# Presentation of Dr. Joram Hopenfeld to the ASLB in Response to Dr. Horowitz Regarding CHECWORKS

Indian Point License Renewal Proceeding  
Adjudicatory Hearing  
October 15, 2012

**Figure 1A -Shows how almost all the non-conservative data points appear to be bound by the -50% line**

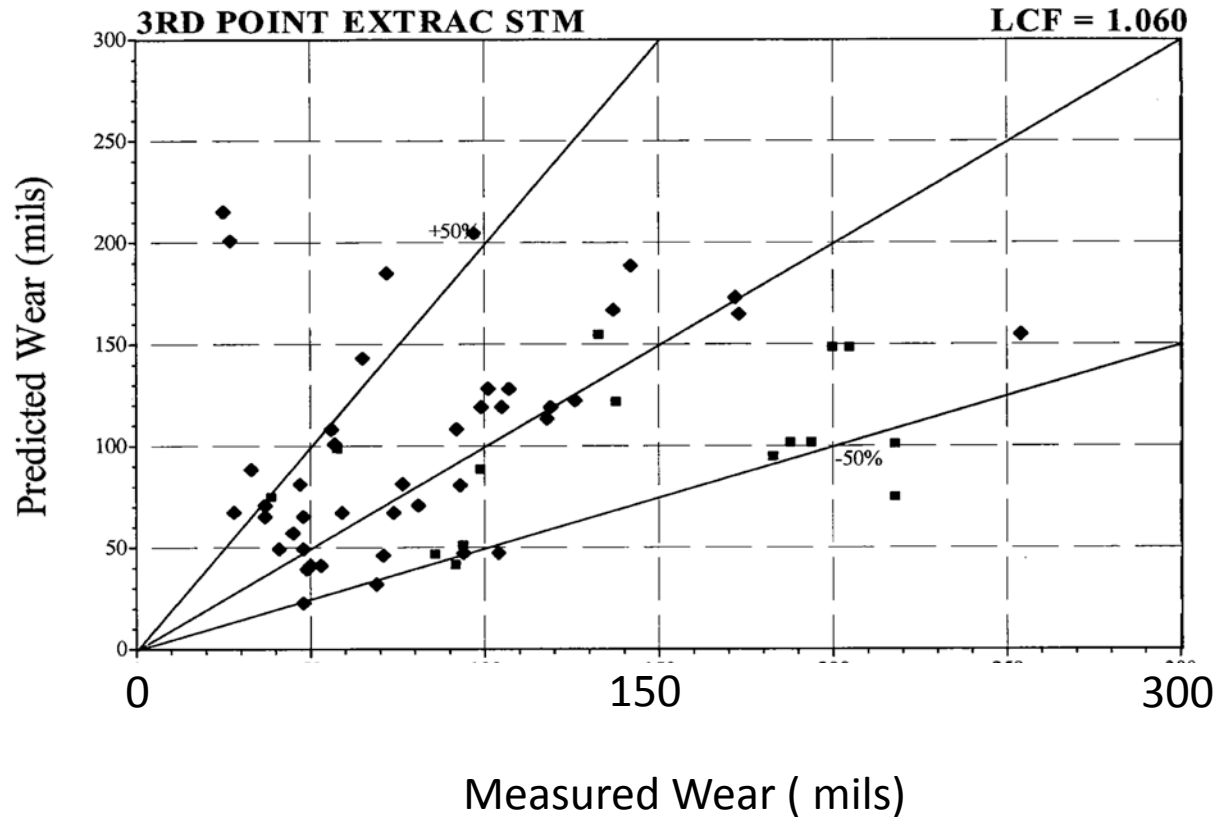
CHECWORKS predictions are presented in a manner that hides the degree of non-conservatism, resulting in misleading plots.

- As shown in Figures 1A and 1B, interchanging the y and the x axes , increases the number of non-conservative points, exceeding the 50% line, by a factor of 6.
- The upper line is labeled +50% instead a +100%, misrepresenting CHECWORKS' accuracy

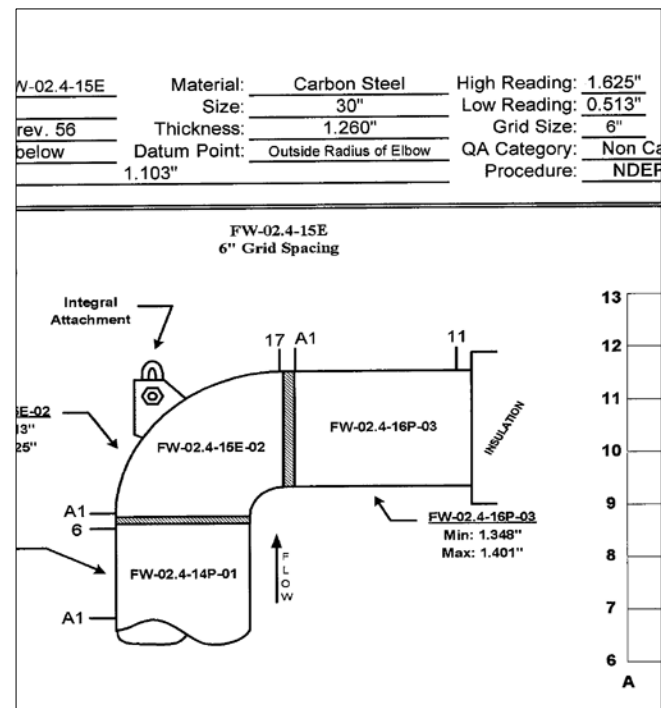
MTCRE criteria can determine whether FAC is controlled by chemical dissolution or erosion

- Chemical dissolution controlled:  $MTCRE < 1.6$
- Erosion controlled:  $MTCRE > 1.6$

Elbow. Max. metal loss: (pt1)  $1.446 - 1.325 = 0.121''$  (Pt2)  $1.547 - 0.513 = 1.034''$

Straight pipe, Max. metal loss :  $1.399 - 1.379 = 0.020''$

Metal loss Ratio, (Elbow /straight pipe):  $(0.121/.02)$  &  $(1.034/.02)$  i.e. **6 to 52**

**Conclusion:** If metal loss were controlled by dissolution alone it would have not exceeded 1.6X; in fact it exceeded it by 6X to 52X, meaning that FAC is controlled by both chemical dissolution and erosion.

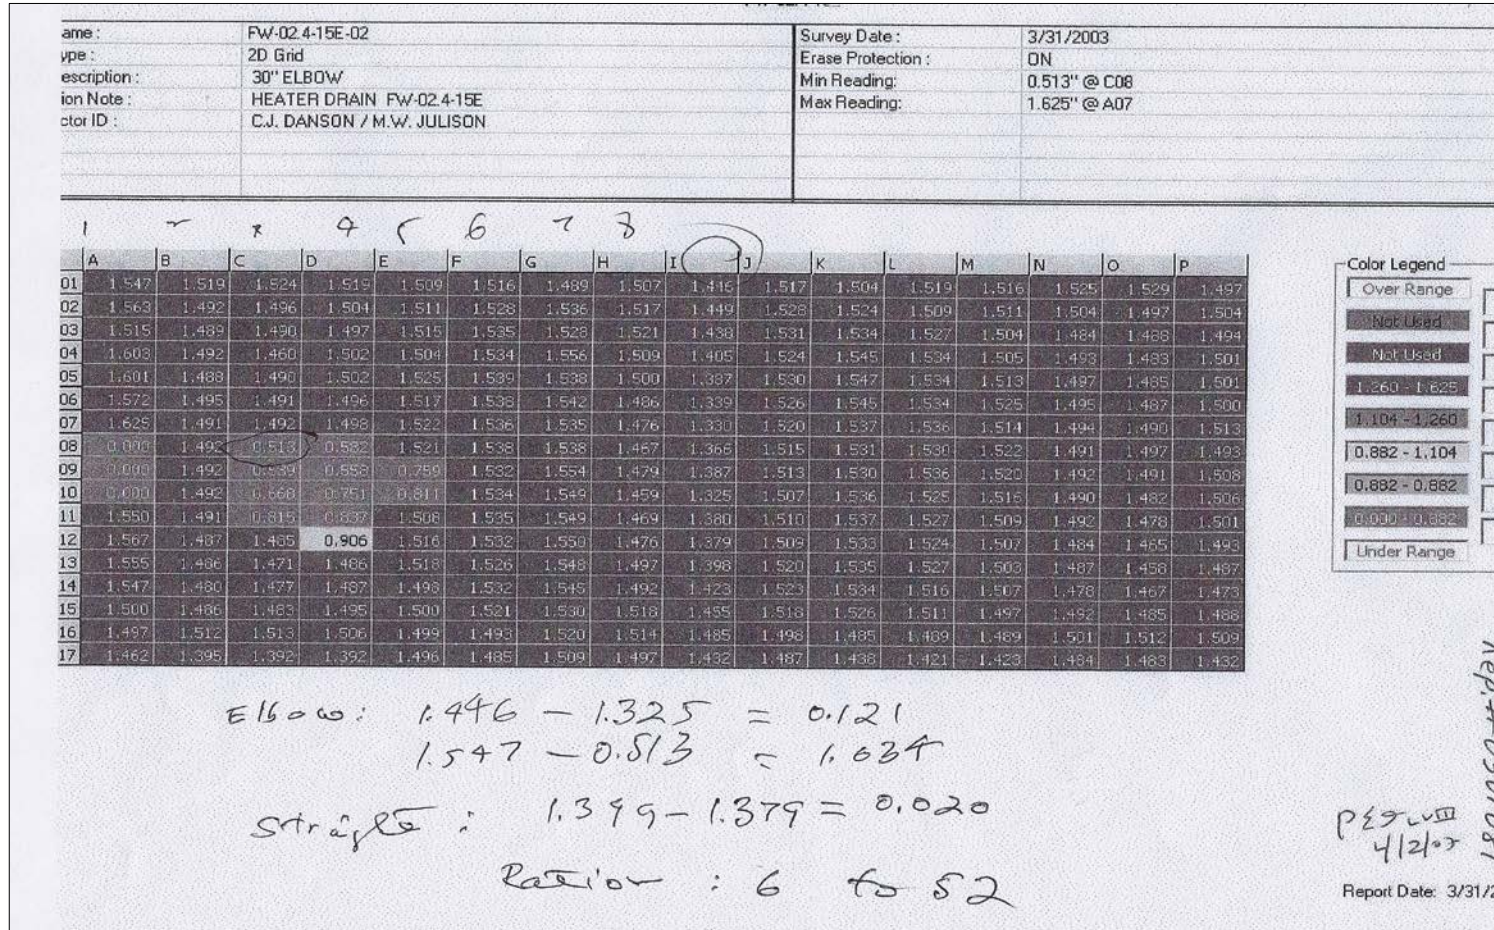
Abrupt local thickness despite Entergy claim that FAC is uniform:

- Elbow's thickness varied from 0.257" to 0.059", (77%), more than 30 component grids exhibit large local variations, yet Entergy does not consider FAC as a local phenomenon (reference: Testimony of Entergy Witnesses Regarding Contention RK-TC-2, ENT000029, at p.54)
- Unpredictable component to component local thinning variation (geometry changes with time)
- CHECWORKS comparison of local thinning predictions with measurements was never provided
